June 5, 2002

**Subject: Meade Street Operable Unit, Subunits 1 and 2A  
U.S. Army Corps of Engineers File Number 26417S**

## II. Proposed Modifications to the Project

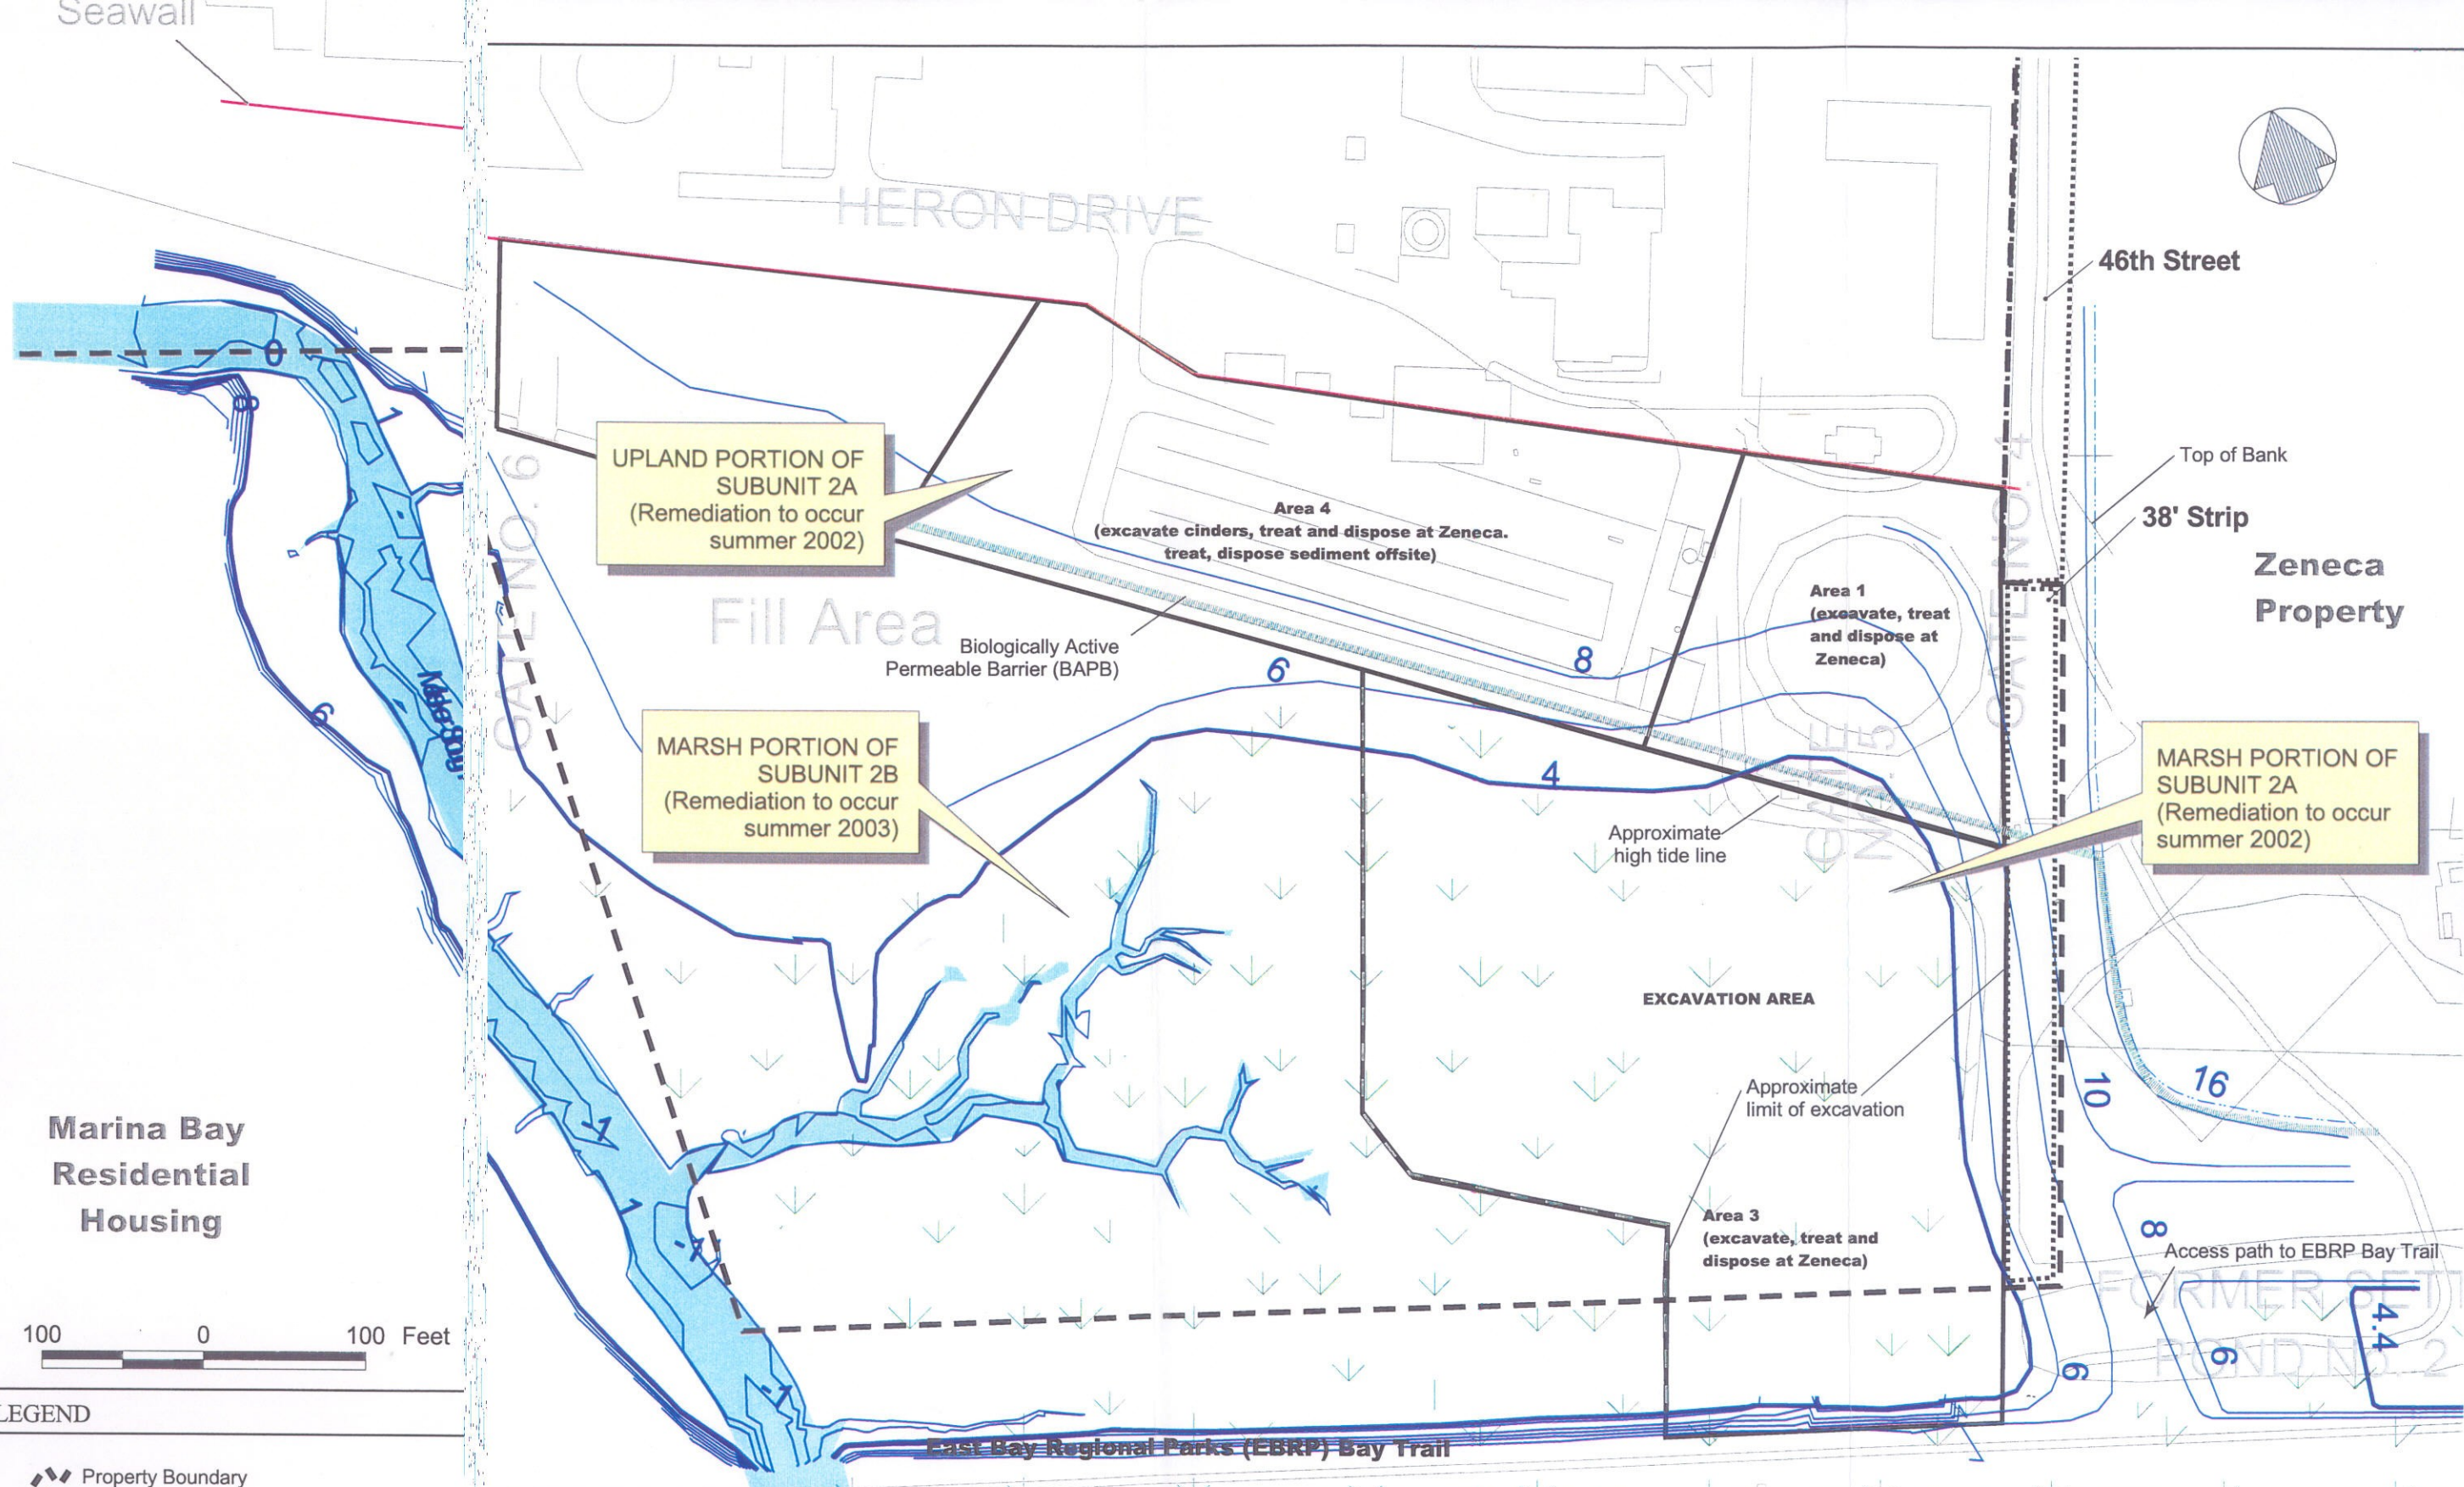
As depicted in the LFR documents submitted to your office, the extent of the remedial activities to be conducted currently includes the upland portion of the Subunits 1 and 2A and the area characterized as the "orange pond" located in northeastern portion of Western Stege Marsh (See Figure 4). We respectfully request to extend the remediation boundary to include a portion of Western Stege Marsh as depicted in Figure 5. The additional area includes approximately 2 acres of contaminated sediments. The area is being expanded based on additional data that has recently been collected to comply with the RWQCB request to delineate the western extent of contamination in Subunit 2A. The results indicate that the area west of the orange pond is heavily contaminated with heavy metals, which pose a significant threat to wildlife that inhabit the marsh. A further discussion of the chemical and physical characteristics as well as the risks to the ecological community for the additional remediation area is provided in the following section, Section 3.

In conclusion, we respectfully request to extend the remediation boundary of Subunit 2A to include a portion of Western Stege marsh as depicted in Figure 5. In addition, we would like to request that the to begin excavation activities on August 1, 2002 for the upland portion of Subunit 2A and the upland portion of Subunit 1 addressed in this letter. As discussed above, the proposed changes to the boundary of Subunit 2A and modification to the construction schedule will not result in adverse effects to SMHM or CCR with the following proposed avoidance and minimization measures:

University of California, Berkeley Richmond Field Station		
<b>URS</b>		
Post Remediation Grading Plan		
May 2002	Scale 1" = 100'	Figure 6

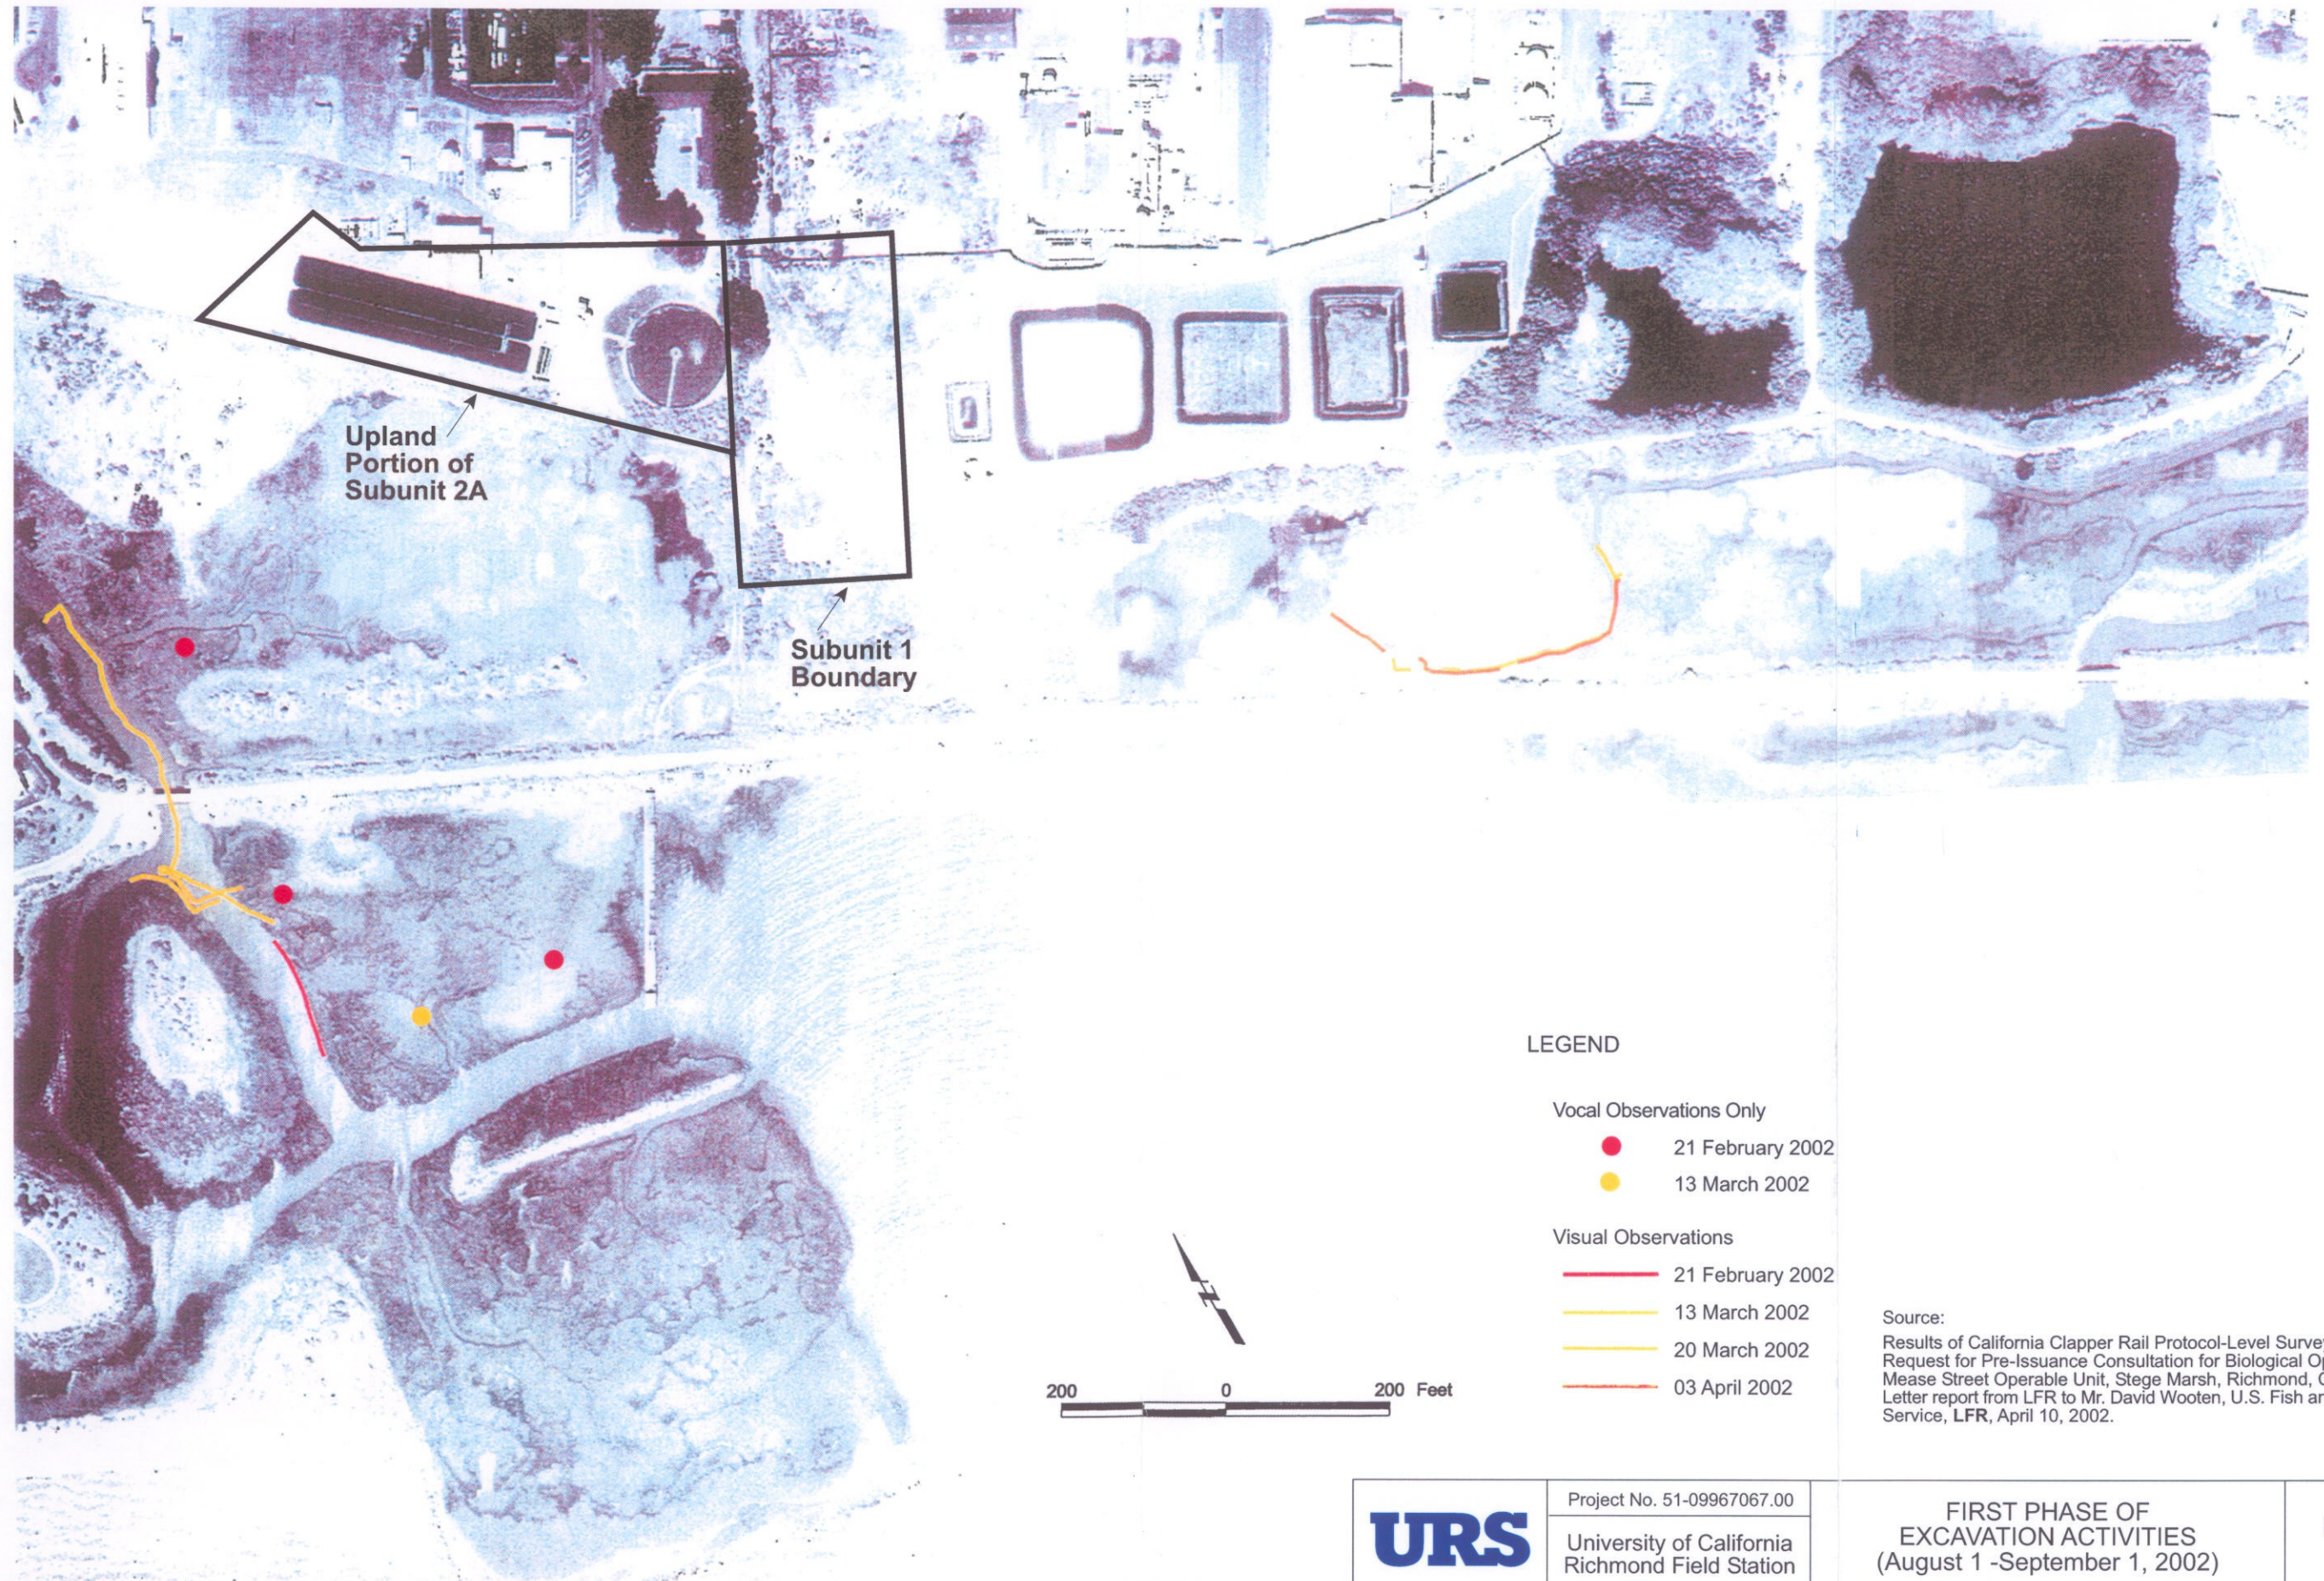
The remedial design for the additional marsh acreage is identical to that described in Section I above except for the volume of material to be treated. Approximately 9,000 additional cubic yards of cinders and sediment would be excavated and treated from the new area. The estimated depth of the excavation is approximately 2 to 3 feet below sediment surface (bss). Once the sediment and cinder material is excavated, the area would be backfilled with clean fill and contoured to support a high marsh area and gradual upland transition zone as shown on Figure 6.

Native vegetation appropriate for the elevation contours will be planted at the end of construction activities.
